APPEAL SUMMARY

Building/Business Name: adidas North Building

NORTH BUILDING - INTERIOR DETAILS -
SHAFT 01

Client Name:	Lever Architecture		
Project Number:	C00166-004A.2	Date:	8/16/2019
Distribution:	Chris Grosse		
Subject:	Combination Fire/Smoke Damper Separating Vertical Shafts		
Referenced Codes and Standards:	2014 Oregon Structural Specialty Code (OSSC), including Appendix N		
Building Name:	adidas – North Building		
Room Area Affected:	Vertical Shafts

A1.603

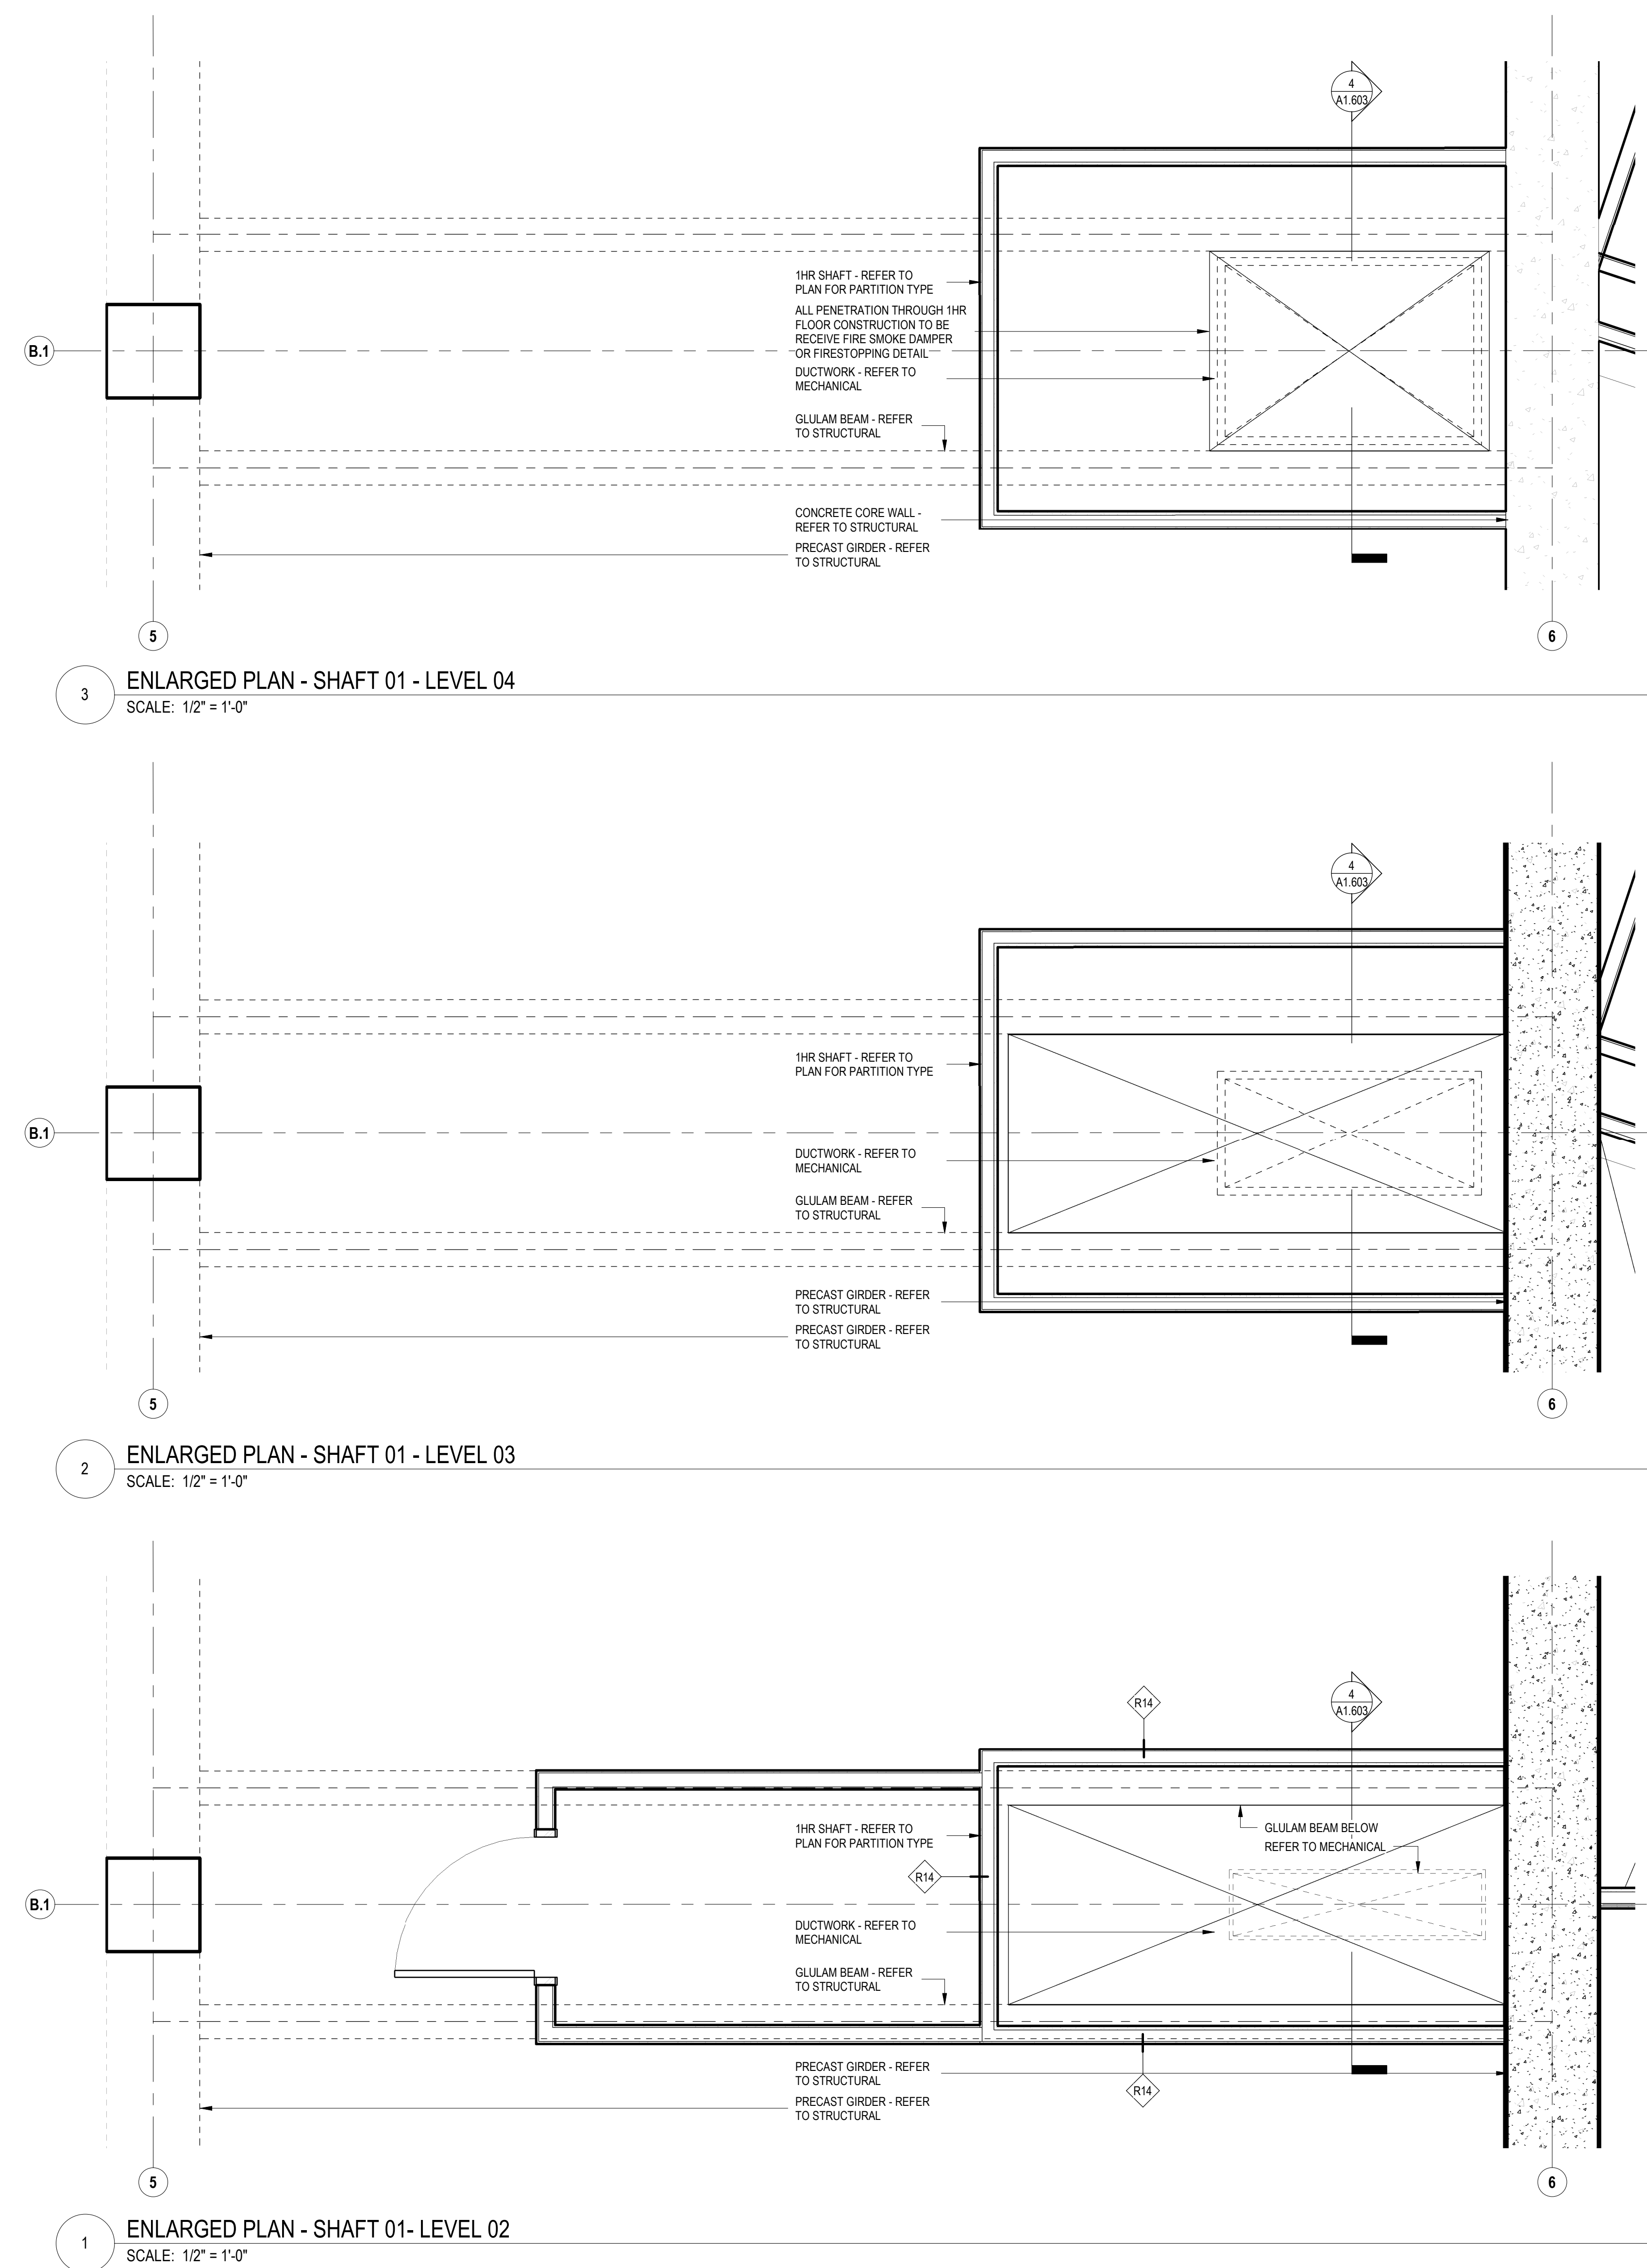
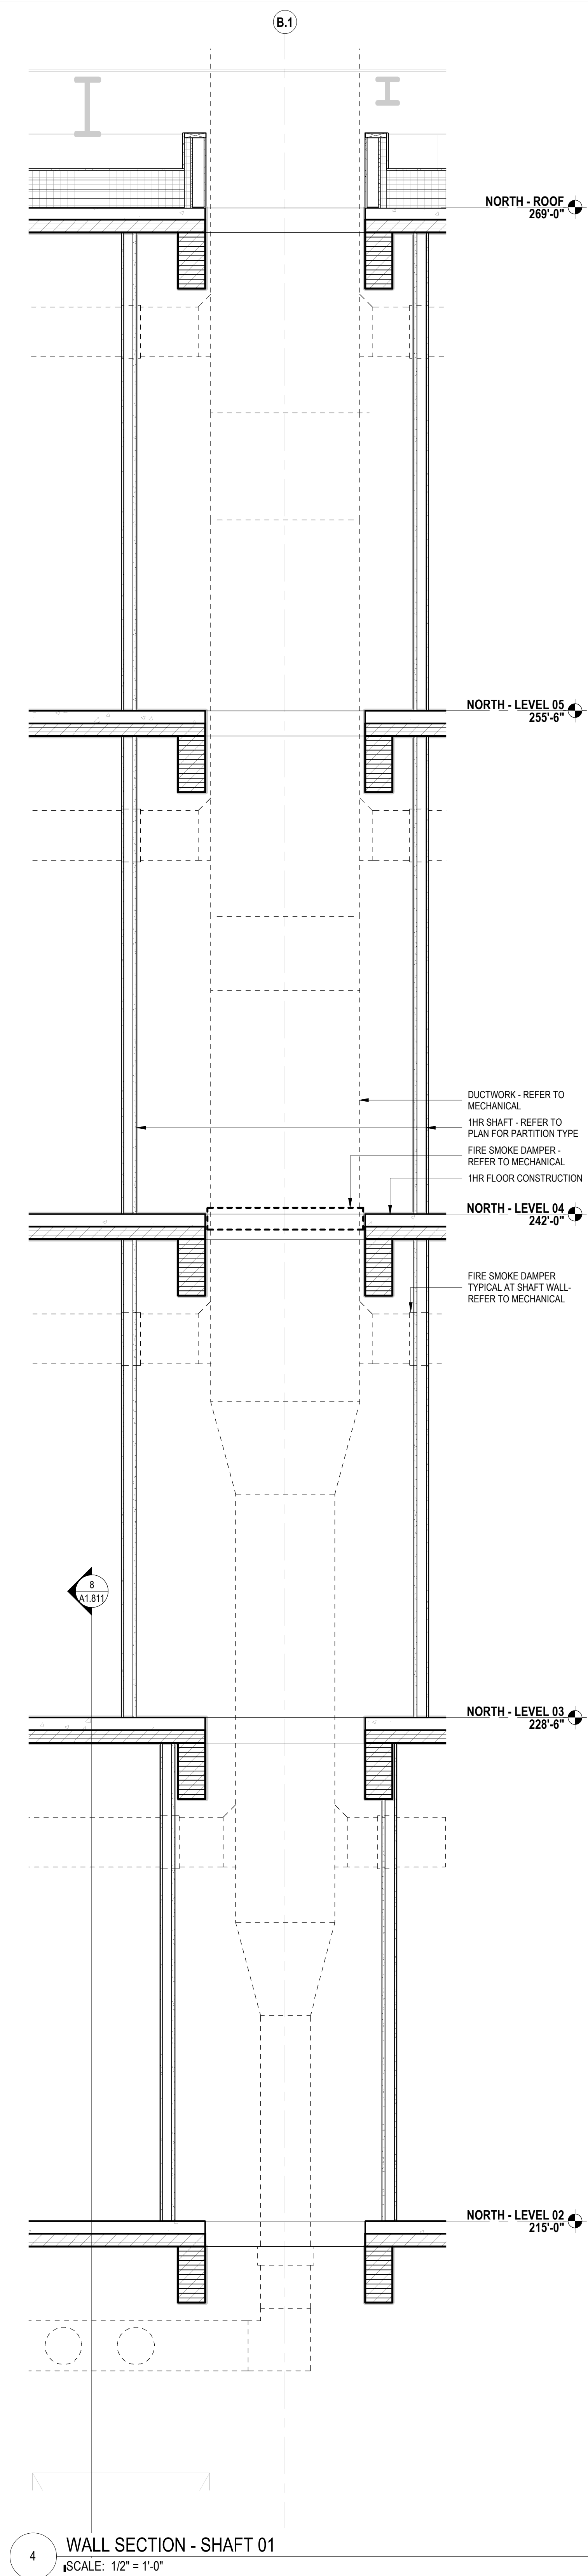
Current design has unprotected beams running through multiple shafts. Due to shafts running vertically more than 3 stories, it was noted during plan review that structure that supports two hour shafts is also required to be 2 hour rated.

Reviewed with architect that the beams could be calculated for char, wrapped with gyp, or a combination. Applicant returned with Code Unlimited memo stating that rated FSD's is a prescriptive code path to allow for vertically stacked shafts, then reviewed with senior plans examiners and determined that this strategy would require a building code appeal.

Reviewed with the applicant that the appeal should provide a detailed explanation demonstrating that UL 555 is equivalent to UL 263 or ASTM E 119, as the FSD needs to function to the same level as a tested and rated horizontal assembly (713.2 shafts shall be constructed as fire barriers or horizontal assemblies, or both – doesn't clearly say or section 717). I would also expect the appeal to clarify the mechanical functions in the shaft as an activated FSD might impact potentially required building mechanical systems during an emergency event.

Contrary to the appeal text, it is not uncommon and costly to build 2 hour shaft walls, since 2 hour shaft walls are highly prevalent in apartment building construction.

It seems that providing two hour rated beams in the shaft and 2 hour rated shaft walls would be a more appeal friendly strategy. This would allow for protection in hidden enclosed areas while beams that are visible in the adjacent office spaces may be unprotected since fire damage would be noticed by building occupants.

Figure 1: Plan view of vertical opening in shaft between Floors 3 and 4.

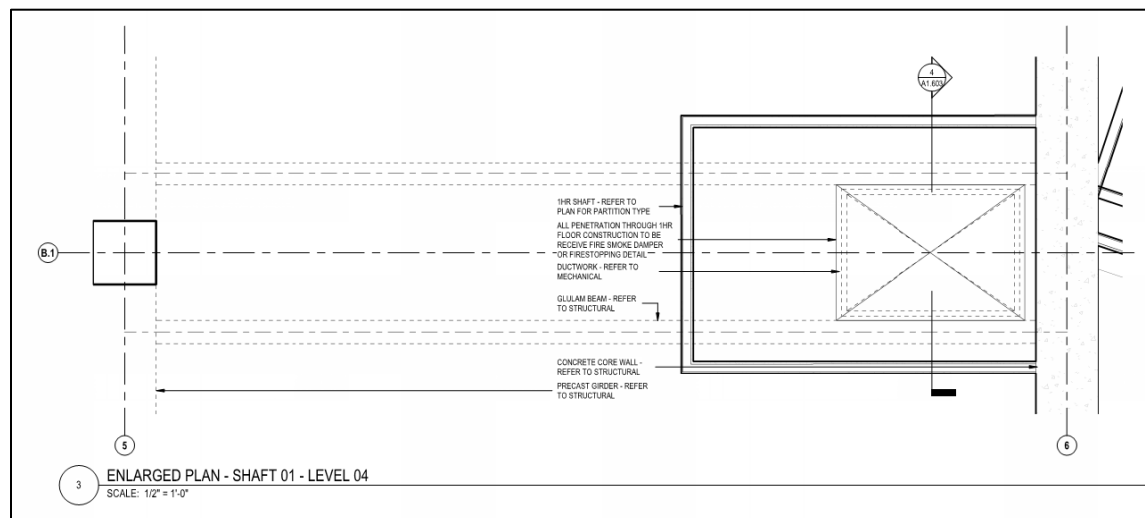
The proposed arrangement of the required combination fire and smoke rated damper at the floor/ceiling assembly inside the vertical shaft is illustrated on Sheets A1.603, A1.604, A1.605, and A1.606 of the architect's permit set dated 7/31/2019 (see Figures 1 and 2 below for typical condition). These details illustrate prescriptive compliance with the provisions of OSSC §711.7 and §717.3.2.3,
